OAK BROOK
Illinois

ITEM 5.A.
COMMERCE PLAZA
COMMERCE PLAZA PROPERTY, LLC
2001-2015-2021 SPRING ROAD
Restaurant - Planned Development

REVISED STAFF REPORT

CASE FILE NO: 2019-03-ZO-PUD

L-1

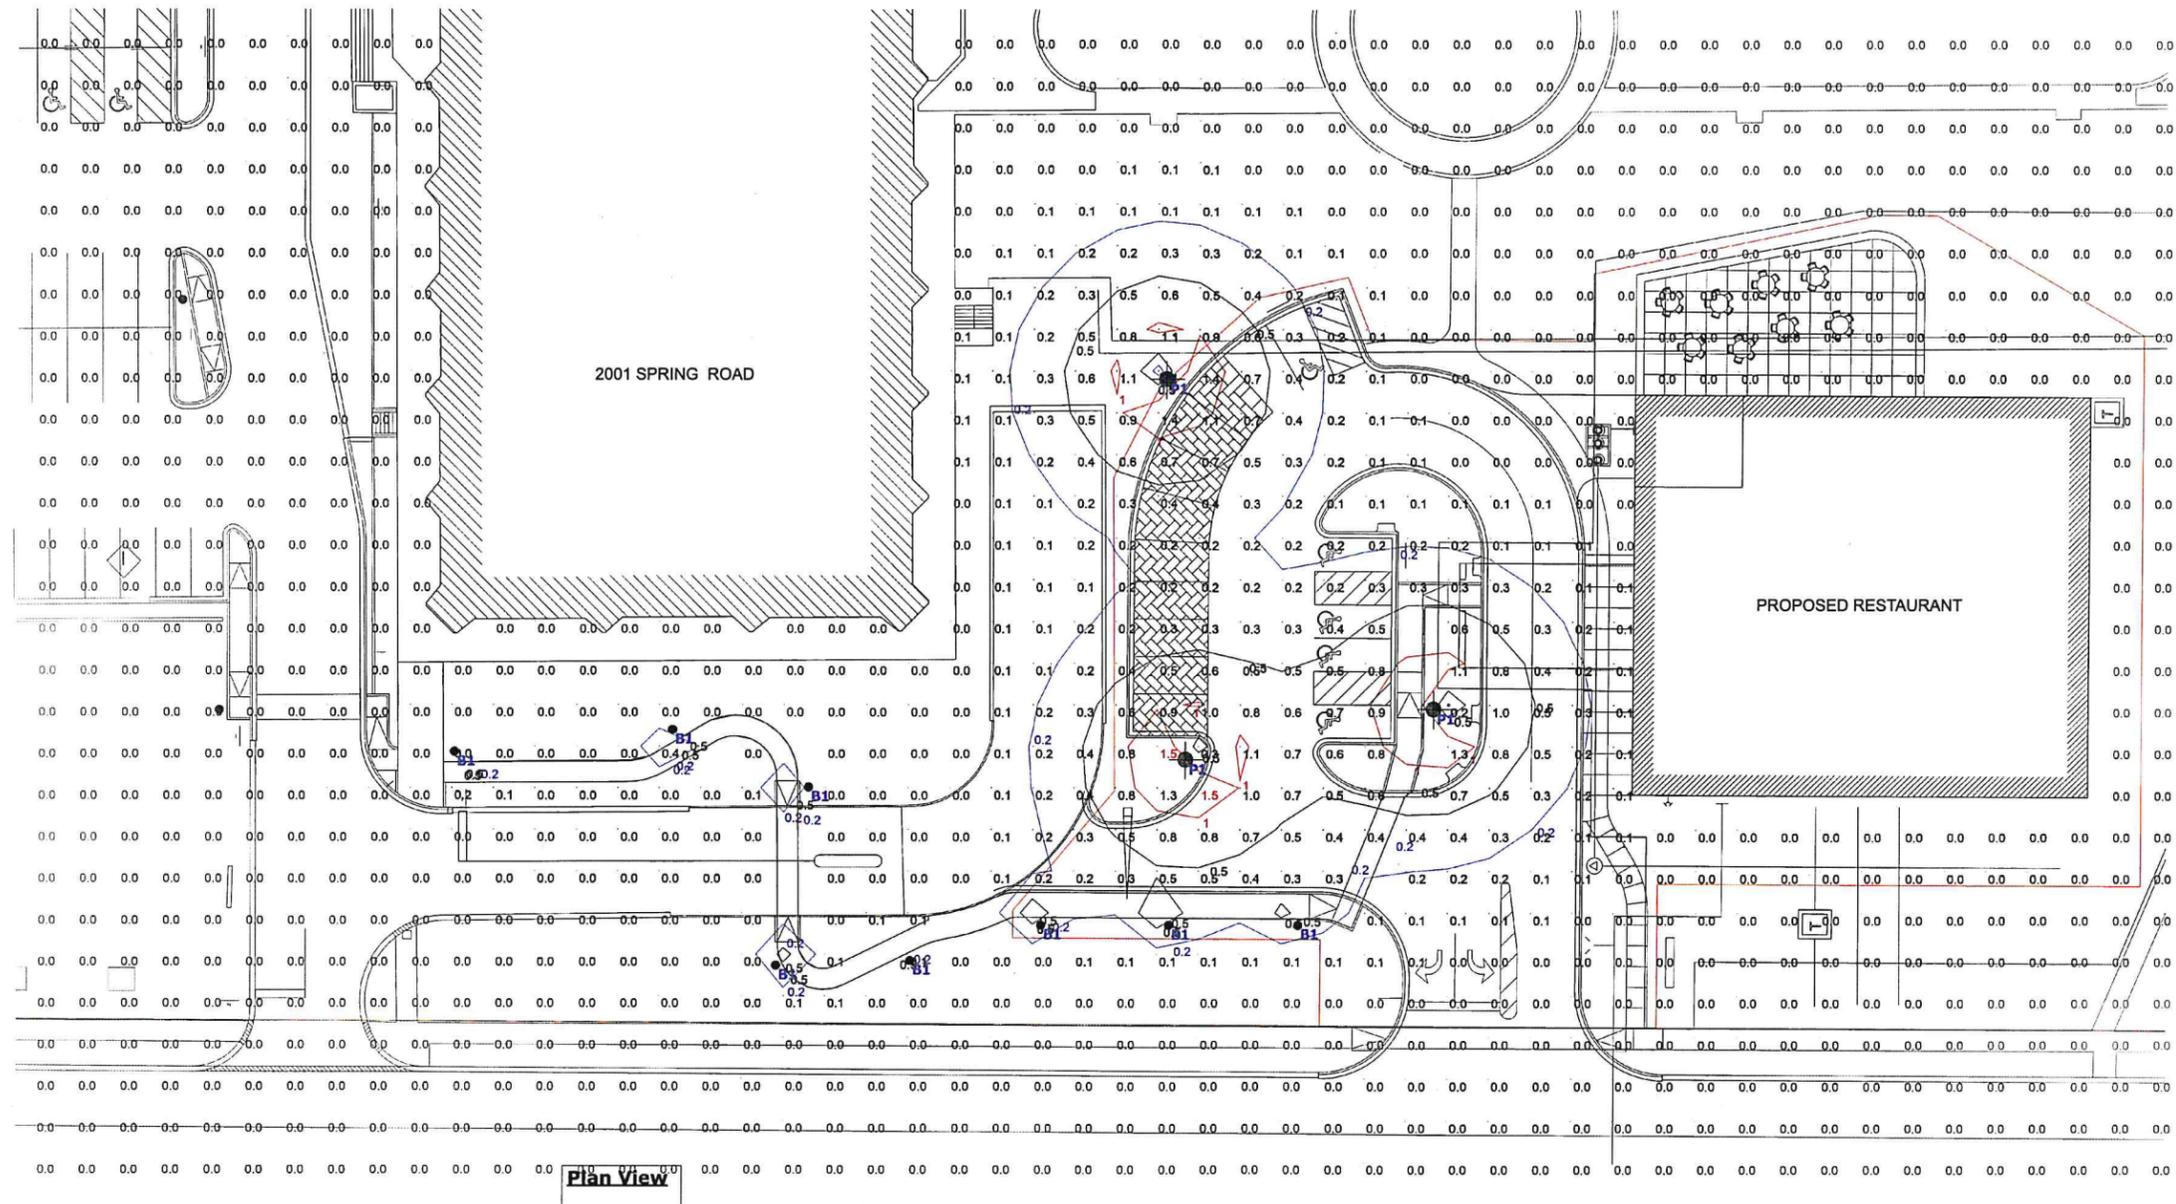
Site Lighting. The current lighting plan (L-1) shows three (3) new 16' high light poles being added to the proposed parking lot. In addition, several additional 36" high, lighted bollards will be added for security and pedestrian safety. The photometric analysis identifies the lighting levels are code compliant at the property line and measure 0.0 foot-candles. The applicant does understand specific consideration should be given to the site lighting with an emphasis on backlighting, up lighting and glare for energy efficiency, aesthetics and nuisance considerations.
